INFORMATION REPORT

TO: Chair and Members Planning Committee	WARD(S) AFFECTED: Ward 3			
COMMITTEE DATE: December 4, 2012				
SUBJECT/REPORT NO: Pan Am Stadium (PED12218) (Ward 3) (Outstanding Business List Item)				
SUBMITTED BY: Tim McCabe General Manager Planning and Economic Development Department	PREPARED BY: Heather Travis (905) 546-2424 Ext. 4168			
SIGNATURE:

Appendix "A" to Report PED12218 (Page 1 of 1)

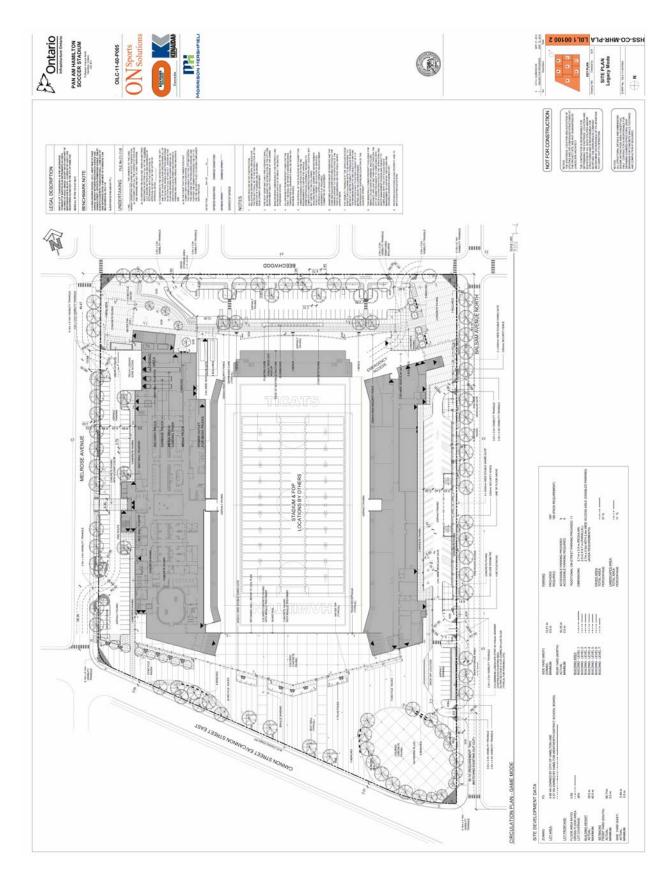
meeting, staff outlined several areas of concern related to urban design issues based on a review of the submitted plans and the Urban Design Report prepared by the applicant. The primary areas of concern which are critical to ensuring the City's Urban Design policies within the Urban Hamilton Official Plan and Site Plan Guidelines are satisfied are:

- 1. <u>Design of the Exterior Facades of the Building</u> The facades of the Stadium should present a new and high quality architectural expression. The "look" of the Stadium is an important part of Hamilton's civic and cultural image, and should be comprised of design elements that represent to Hamiltonians and visitors a lasting and positive visual experience. Exterior materials should be a high quality to create a building base that visually references the buildings surrounding the site. Areas beneath the stands should be visually screened, and large areas of blank walls should be treated architecturally to create visual interest.

- 2. <u>Design and Function of the Civic Plaza</u> The civic plaza should be of a high quality design that is inviting, comfortable, and welcoming, and be functional for both game and non-game days. Seating, shade, greenery, and visual interest should be provided. The civic plaza should become a civic landmark. The plaza should offer opportunities for social interaction and large and small community events such as farmer's markets, fairs, and food events. Consideration should also be given to lighting and the night-time experience, and the inclusion of public art.

- 3. <u>Completion of Sun/Shadow Study</u> The proponent has been advised to provide an analysis of the sun/shadow impacts of the proposal by comparatively analyzing these impacts against those of the existing Stadium, the Indicative Design, and the proponent's proposal.

- 4. <u>Completion of Urban Design Brief</u> The proponent has been advised to submit a revised Urban Design Brief, which demonstrates how the proposal is in keeping with the requirements staff had identified with respect to the Indicative Design, and how the proposal is guided and informed by the Council-approved Site Plan Guidelines. The Brief should demonstrate and explain the features of the overall design, the civic plaza, and the architectural expression, and include language that speaks to the intended goals and experiences.

- 5. <u>Other Site Design Details</u> Other issues that must be reviewed and addressed include landscaping, pedestrian and cycling facilities, Urban Braille, wayfinding, and public art.

Staff identified that the proposed Site Plan for the Pan Am Stadium did not comply with all regulations of Zoning By-law 05-200, and that the following variances to the Zoning By-law would be required:

- 1. Parking spaces and aisles shall be located closer than 3.0m of a street line along Melrose Avenue, Beechwood Avenue, and Balsam Avenue, instead of the required 3.0m from the street line;
- 2. Planting strips shall not be provided along Melrose Avenue, Beechwood Avenue, and Balsam Avenue, instead of the minimum 3.0m planting strip required;
- 3. No access aisle shall be provided for the parallel parking spaces along Beechwood Avenue;
- Parallel parking spaces along Beechwood Avenue shall not provide for ingress and egress of vehicles on the lot, or access to and from a street in a forward motion only;

- 5. A minimum angled parking space length dimension of 5.2m shall be provided, instead of the minimum required 5.5m; and,
- 6. A minimum barrier free parking space width of 3.9m shall be provided, instead of the minimum required 4.4m.

The applicant submitted an application for approval of a Minor Variance (HM/A-12:245), which was scheduled for a Hearing before the Committee of Adjustment on November 15, 2012. Prior to the Committee of Adjustment Hearing date, the applicant revised the proposed Site Plan to remove the lay-by parking that had been proposed on Beechwood Avenue. Further, the applicant revised the parking area on the Balsam Avenue side of the Stadium in order to ensure that all parking spaces met the minimum required length of 5.5m. The applicant also revised the Plan to increase the width of barrier free spaces to 4.4m. As a result of these revisions, variances 3, 4, 5, and 6 noted above are no longer required. Further, Variances 1 and 2 above are only applicable to the Melrose Avenue and Balsam Avenue frontages. As such, the following variances to the By-law are required:

- 1. Parking spaces and aisles shall be located closer than 3.0m of a street line along Melrose Avenue and Balsam Avenue, instead of the required 3.0m from the street line; and,
- 2. Planting strips shall not be provided along Melrose Avenue and Balsam Avenue, instead of the minimum 3.0m planting strip required.
